Joseph M. Farley Nuclear Plant – Unit 1  
Vogtle Electric Generating Plant – Units 1 & 2  
Response to NRC Request for Additional Information Regarding  
Inservice Inspection Alternatives for Reactor Pressure Vessel Examinations

**SNC Response to NRC RAI Related to Request ISI-GEN-ALT-06-02**

**REQUEST FOR ADDITIONAL INFORMATION**  
**BY THE OFFICE OF NUCLEAR REACTOR REGULATION**  
**RELATED TO REQUEST ISI-GEN-ALT-06-02**  
**JOSEPH M. FARLEY NUCLEAR PLANT, UNIT 1**  
**VOGTLE ELECTRIC GENERATING PLANT, UNITS 1 AND 2**  
**SOUTHERN NUCLEAR OPERATING COMPANY**  
**DOCKET NOS. 50-348, 50-424, AND 50-425**

**FIGURE 1**  
(Illustrative Purposes Only - not to scale)

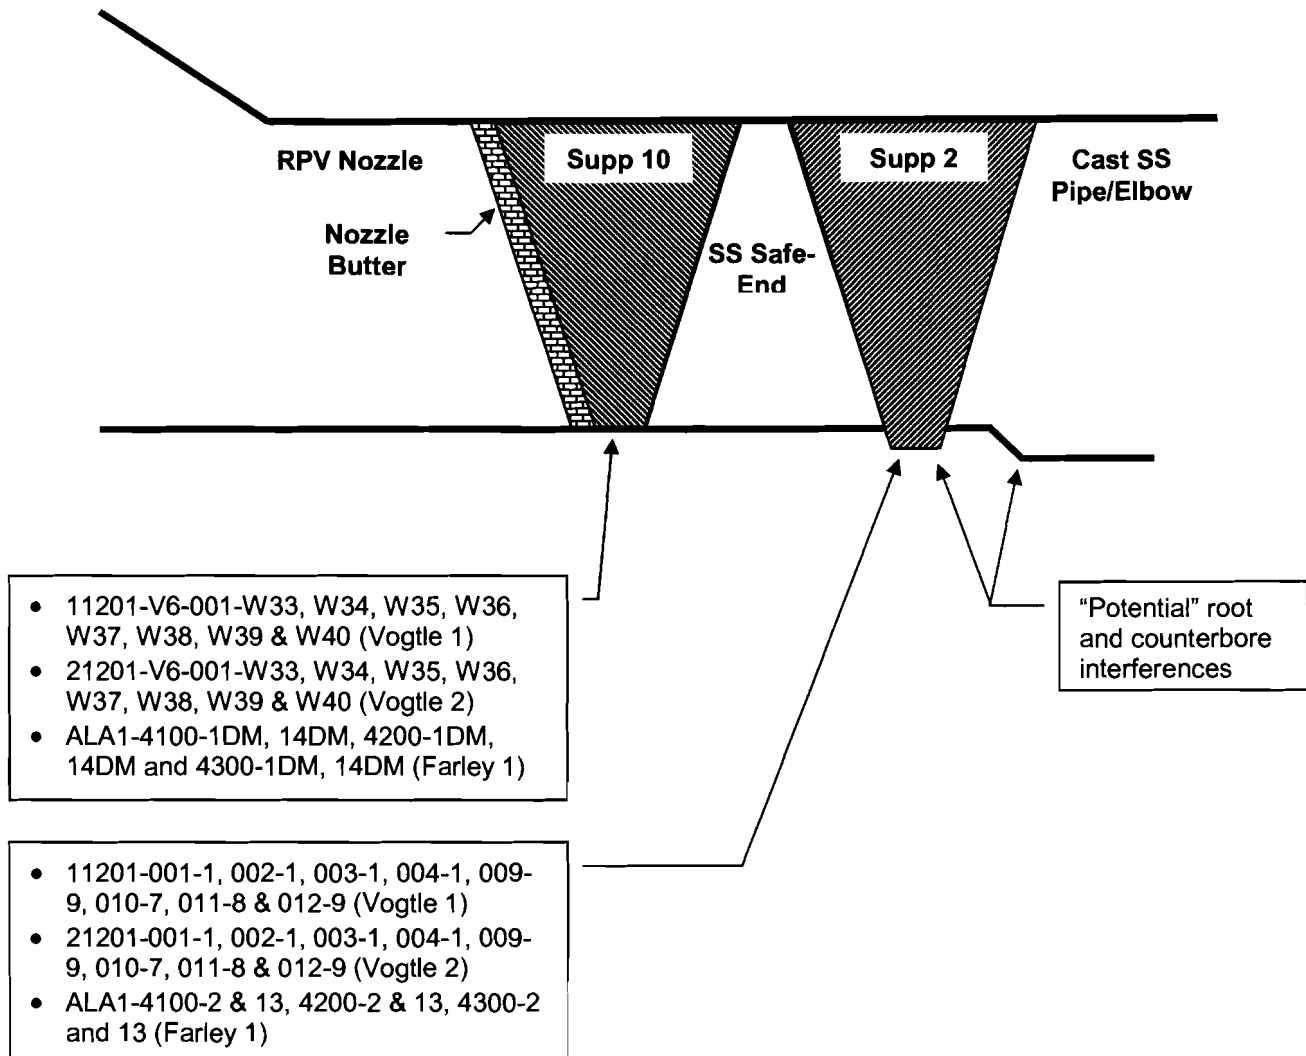
**Explain why the ASME Code RMS value is not achievable for the selected vendor.**

The difficulty of achieving the required 0.125-inch RMS error factor results from ID geometry interferences (e.g., root, counterbore). To accurately size thru-wall indications, the transducers ability to scan over the flaw must not be impeded by these interferences. The qualification mockups for both Supplements 2 and 10 were fabricated from field supplied data, representing the expected worse case scenarios. In most cases, the austenitic joint (Supplement 2) is field welded with root and counterbore restrictions occurring. For most 3 and 4 loop Westinghouse designs, the dissimilar metal (DSM) joint (Supplement 10) has been shop machined, resulting in little or no geometric interferences. Both Farley and Vogtle Supplement 10 configurations are expected to be unimpeded. Therefore, it is expected that the proposed alternative 0.189-inch RMS error factor would be a conservative alternative compared to the qualification specimens. Part of the examination process for remote mechanized inspections is the gathering of profile data. This information is used for coverage determinations. The data is also being collected to ensure qualification mockups represent the full alignment of field conditions within the industry. Surface scan access and/or cast material difficulties restrict the examinations for the Farley and Vogtle configurations from the outside diameter (OD). A figure is provided for illustrative purposes.

As stated in the Diablo Canyon DSM RAI response, dated July 7, 2005, no vendor has demonstrated the ability to achieve a 0.125-inch RMS error value for the Supplement 2 or 10 qualifications when conducting examinations from the ID. This information is still accurate as of August 2006. Studies and projects are currently underway for the examination of cast material. Industry efforts with "phased array" examinations may be able to achieve greater coverage from the OD in the future, which may also aide in thru-wall sizing.
